Office Action Summary

10/031,218

FILSHIE ET AL.

Fig. 1

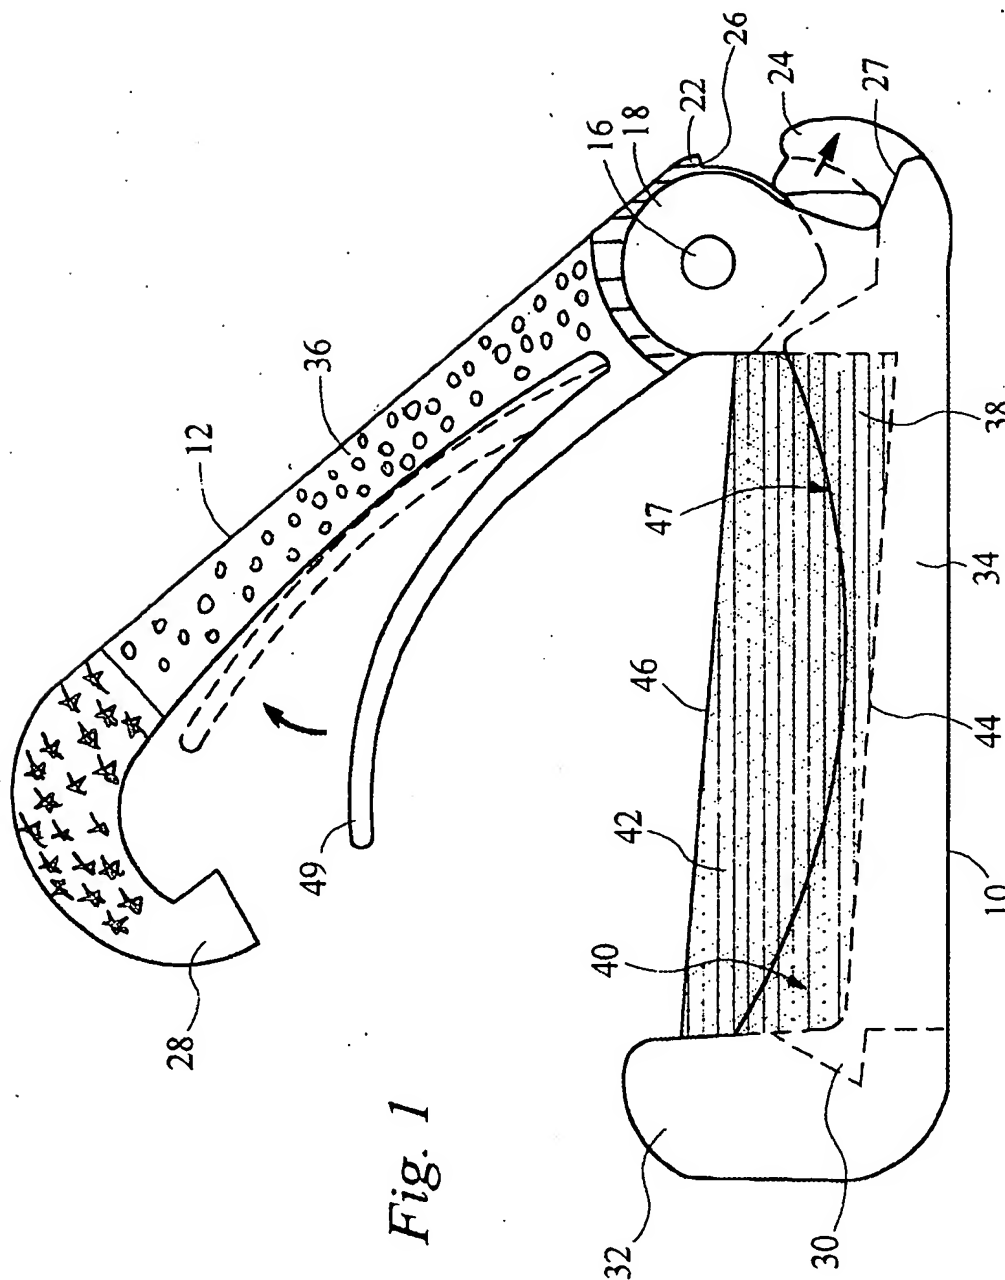
2. Regarding Claim 2, Casey '255 discloses generally straight section (28) [Fig. 1].
3. Regarding Claim 4, straight section 28 extends distally from latching means 30.
4. Regarding Claims 5 and 6, the first and second arcuate shaped portions (denoted respectively by circles and stars in Attachment #1) has the same width (laterally) along its length.
5. Claims 1-3 are rejected under 35 U.S.C. 103(a) as being unpatentable over U.S. Patent No. 4,418,694 to Beroff et al. in view of U.S. Patent No. 6,206,896 B1 to Howell et al. Beroff discloses a surgical clip for clamping blood vessels having upper jaw 11, lower jaw 12, and hinge 13. The upper jaw has straight section 23 and an arcuate shaped section including first portion 22 (larger radius of curvature) and second portion 10 (smaller radius of curvature). Beroff's clip is not lined with silicone rubber.

"In the '255 patent the outer surface where the reference character 12 points to in Fig. 1 is absolutely straight and has no arcuate portion thereto."

That is, the differentiation Applicant is making is that the *radius of curvature* of the outer surface of the *first* arcuate section is larger than the radius of curvature of the *second* arcuate section. U.S. Patent No. 5,846,255 to Casey in view of U.S. Patent No. 4,822,348 to Casey meets this limitation. Although Applicant is correct in pointing out that the outer surface of member 36 is flat, the member 36 taken as a whole can accurately be described as arcuate shaped since its lower surface is curved, and the average curvature of the whole beam (i.e. the center line) is slightly curved.

Regardless, the outer surface of member 12 is not curved, but is a flat surface. Examiner contends, however, that *the radius of curvature of a straight line is infinite*, as

evidenced by "The History of Curvature, page 4 of 7, last paragraph, lines 3 and 4. Therefore, the radius of curvature of the starred section [see Attachment #1 attached hereto] is less than the radius of curvature of the section having circles drawn therein, because the radius of curvature of the outer surface of the section having circles drawn therein is *infinite*.
